DESCRIPTIVE REPORT

Registry No. H-11002

General Locality Southwest Prince William Sound

Sublocality South of Green Island - Vicinity of
The Needle

Figure 2: Junctions with Survey H11002

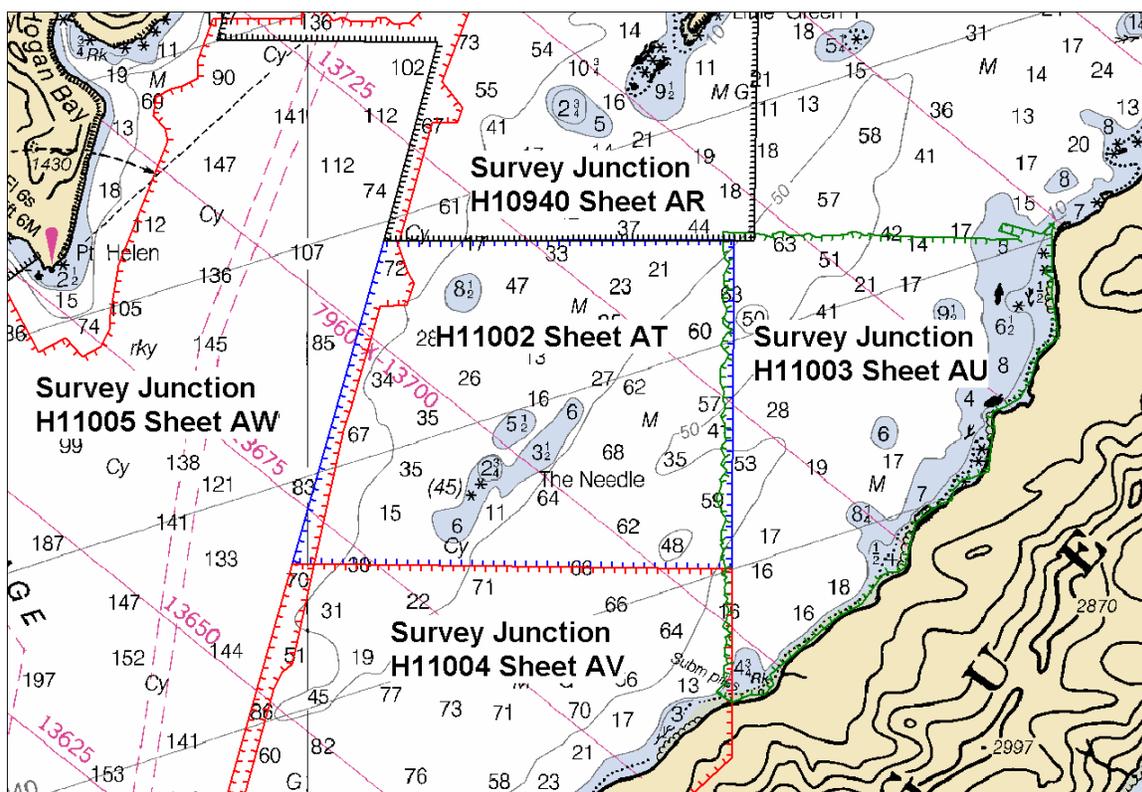
Surveys H11003, H11004, and H11005 junction well with this survey, with differences within one fathom. Survey H10940 junctions well with this survey, with differences generally ranging between one and three fathoms.¹⁰ Notable differences are addressed below.

The present survey shows a 31-fathom sounding at 60°09'33.73"N, 147°35'58.32"W (466720.5 E, 6669311.0 N, Pos. # 267276) where survey H10940 revealed a depth of 25.2 fathoms. This area is over a ridge and was covered with 100% SWMB.¹¹

The present survey shows a 47-fathom sounding at 60°09'31.03"N, 147°33'01.82"W (469441.3 E, 6669203.8 N, Pos. # 423931) where survey H10940 revealed a depth of 42.3 fathoms. This area is over a ridge and was covered with 100% SWMB.¹²

- ⁸ Concur
- ⁹ The junctions with surveys H11003, H11004, and H11005 are complete. A “Joins” note has been added to the smooth sheet where applicable. A few soundings from the junction surveys have been transferred within the common area of H11002 to better delineate the bottom configuration. The junction with H10940 was not formally completed since this survey was processed previously. Depths are generally in good agreement within the common area. However, the standard depth curves on the present survey were drawn considering both data sets and therefore should be used with the common area. An “Adjoins” note have been added to the smooth sheet.

- ¹⁰ Concur with clarification. See endnote 9.
- ¹¹ PHB Revision – 25 fathom depth has been transferred to the present survey.
- ¹² PHB Revision – 42 fathom depth has been transferred to the present survey.
